Access Compliance Report

Public Rights-of-Way

Intersection ID: 31872	Main Street: LANGDEN_GATE_DR	Cross Street: TAPESTRY_WOODS_CT	Location: NE
ADA ID: 68E3676ED51E	Ramp Type: PerpDiag	Initial Pass/Fail: Fail	Overall Compliance: No
Codes/Mitigation Info/Possible Solution		Field Measurements/Component Compliance

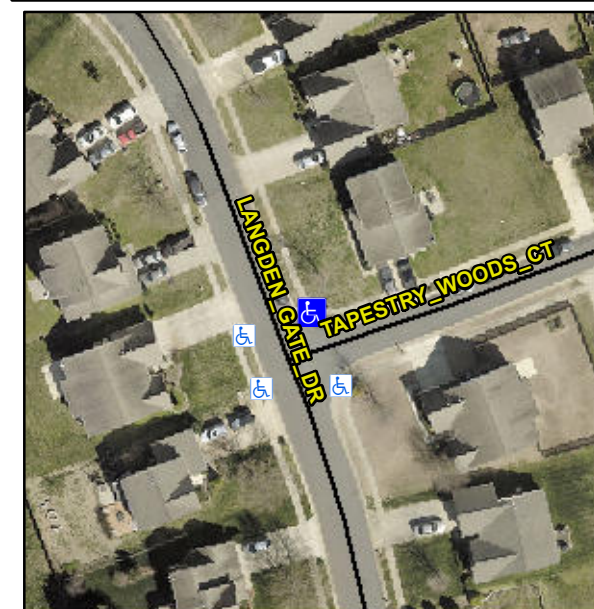
R304.5.1, R304.5.3

Compliance	Description	Data	Compliance	Description	Data
N/A	Ramp Length (in)	45.0	Yes	Ramp Slope (%)	6.8
No	Ramp Width (in)	38.0	No	Ramp XSlope (%)	2.6
N/A	Flare Type LT	N/A	N/A	Flare Type RT	N/A
N/A	Flare Slope LT (%)	N/A	N/A	Flare Slope RT (%)	N/A
N/A	Flare Traversable LT?	N/A	N/A	Flare Traversable RT?	N/A
N/A	Landing Length (in)	N/A	N/A	DWS Provided?	N/A
N/A	Landing Width (in)	N/A	N/A	DWS Contrast?	N/A
N/A	Landing Slope (%)	N/A	N/A	DWS Length (in)	N/A
N/A	Landing X Slope (%)	N/A	N/A	DWS Full Width?	N/A
N/A	Landing Curb? (Y/N)	N/A	N/A	DWS Offset (in)	N/A
N/A	Shared Landing?	N/A			
N/A	Gutter Ponding?	N/A	N/A	Gutter Slope (%)	N/A
N/A	Gutter Lip Ht (in)	N/A	N/A	Gutter X Slope (%)	N/A
N/A	Painted X Walk1?	No	N/A	Painted X Walk2?	No
	X Walk 1 Direction	To SW		X Walk 2 Direction	To SE
N/A	X Walk 1 Width (in)	N/A	N/A	X Walk 2 Width (in)	N/A
	X Walk 1 Slope (%)	1.3		X Walk 2 Slope (%)	0.7
	X Walk 1 X Slope (%)	0.1		X Walk 2 X Slope (%)	2.1

Remove & Replace Curb Ramp With Two New Directional Ramps or Equivalent.
